**5517B-05A**

# S E R V I C E N O T E

## 5517B Laser Head

### Controller Board A3F1 Nuisance blows

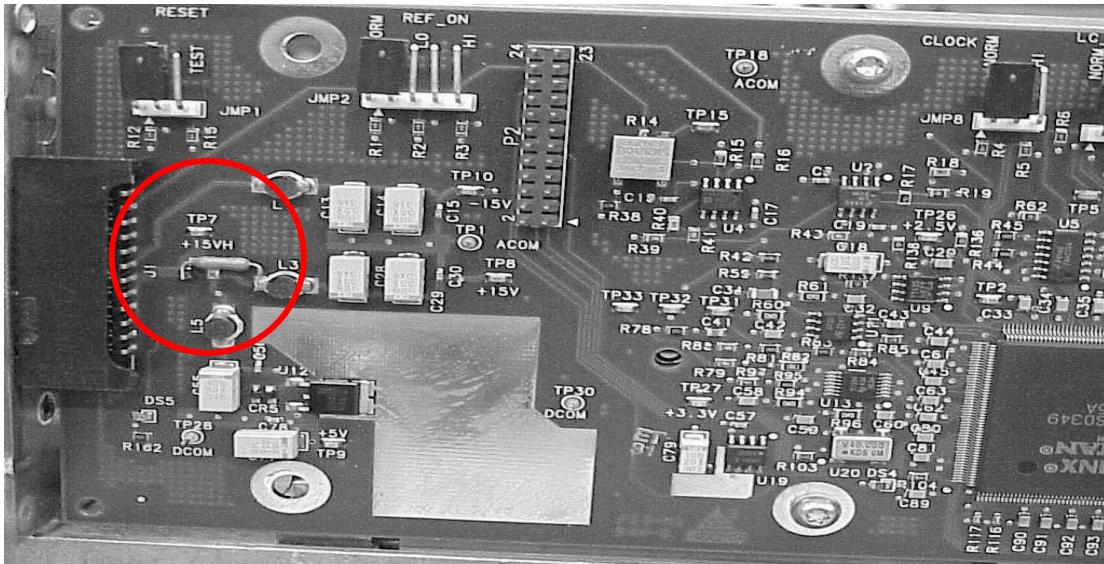
Agilent has identified some applications in which there is nuisance blows of the fuse (A3F1) on the laser controller board (05517-60031). This is a secondary fuse; the main fuses are not affected.

The observed mechanism is: READY light not illuminated, other three LEDs are illuminated. Laser does not progress through a normal power-up-and-ON operating sequence.

Nuisance fuse blowing is sometimes seen when the laser head is operated in a high temperature environment with limited to no air circulation around the unit. This condition causes very high temperatures inside the laser, greatly reducing the operating margin for the fuse.

We recommend that we remove the 0.5A surface mount fuse and replace it with a 0.63A through hole fuse (see picture below). After replacing the fuse the laser head needs to be powered up to ensure the unit is working. Additional test are optical power and split frequency tests. No adjustments are needed. Also, to identify laser heads that have had the fuse replaced, we recommend a label be placed on the rear panel (see picture below).

Picture shows the 0.63A TH fuse installed.
